4352B-10A

S E R V I C E N O T E

Agilent 4352B VCO/PLL Signal Analyzer

Part number changes for LCD

COLOR LCD ASSY (E4970-65001) part:

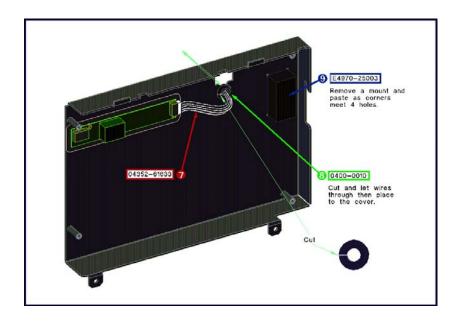
The LCD (P/N 2090-0574) used in the 4352B was obsoleted and replaced with a new LCD. When the LCD is defective, use new replacement LCD P/N 2090-0361 or LCD ASSY P/N E4970-65001.

The new LCD has different assembly size from old one and is used with a new inverter board for backlight. The LCD and GSP board are required for replacing the LCD depending on instrument serial number.

Ref Desig	Agilent Part Number	Qty	Description
1	04352-04014	1	Cover
2	04352-25002	1	Insulator
3	0950-4111	1	A54 Inverter Board
4	0515-0977	2	SCR-MACH M2X0.4
5	2090-0361	1	A52 LCD
6	04396-25071	1	Gasket
7	04352-61633	1	Cable Assy
8	0400-0010	1	Gromet
9	E4970-25003	1	Sponge
10	E4970-66540	1	LCD MINI-BD
11	0515-1550	4	SCR M3-L8 P-H
12	E4970-61651	1	FLAT CBL FFC
